Committee of the Whole Report

Subject: **Rezoning Application No. 00873, Development Permit with Variances Application No. 00269, Heritage Alteration Permit No. 00269 for 603 Pandora Street and associated Official Community Plan Amendment**

Figure 2. Shadow analysis at 12 noon during equinox at 15m (approximately 5 storeys)

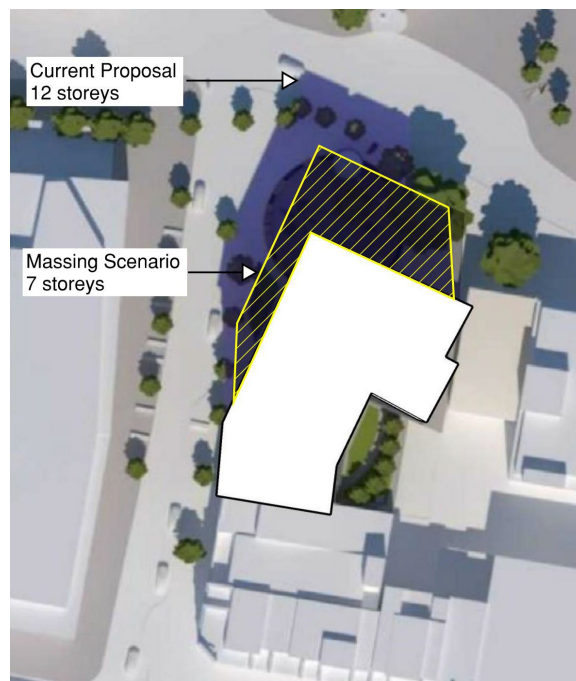
The applicant has provided a shadow analysis that demonstrates that the sidewalk to the north of Pandora Avenue meets this requirement, however the plaza has not been factored into the calculations. Although efforts have been made to improve access to sunlight in the north facing plaza by offsetting the building from the west (Government Street) property line, the shadow analysis highlights that the entire plaza will remain shaded even at midday during the equinoxes.

Staff prepared a massing scenario at the policy compliant 15m maximum height limit as well as a modest increase above this at 22.5m (illustrated by the yellow hatched overlay area in Figure 2 and Figure 3), which demonstrates that a significant improvement in access to sunlight would be achieved through lower building heights.

Given the negative impacts of shading on the proposed plaza and the detrimental impact the proposed building would have on the character of Old Town, it is recommended that Council decline the proposed height variance. Staff have prepared an alternate recommendation that directs the applicant to revise the proposed height and massing to better align with policy. This would require a reduction in height from the currently proposed 12 storeys to a maximum of approximately 7 storeys (a reduction of 5 storeys).
